SONARtrac[®] Technical Bulletin		
	Subject: Transmitter Undetermined Value Option	TB027	Rev: 01
		Priority: 5	
			Page 1 of 3

ECO E14-0037 has been issued that formalizes the release of Firmware Version 04.10.01. This firmware contains a new transmitter configuration parameter called “Undetermined Value” option.

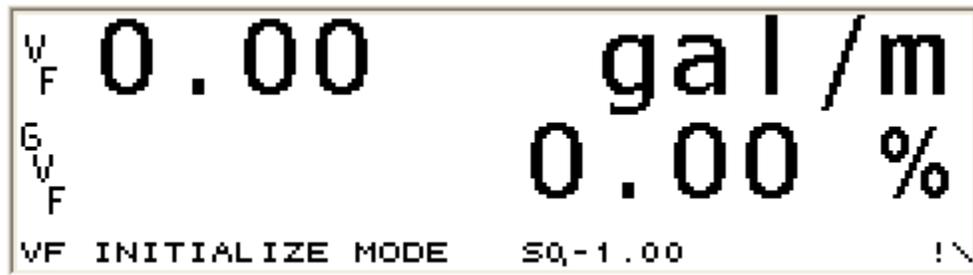
When the “Zero” option is selected, the outputs will be as follows:

- MODBUS (Foundation Fieldbus and Profibus): Change register values to 0, not NaN
- Display: Display a 0 instead of dashes
- 4-20: Output the mA value for 0 (not 0mA).
- Data History: Change display values to 0, not NaN
- HART: No change to its code, but will report 0 for reported values
- Results Messages: No change – results as reported from algo as before (was never NaN)
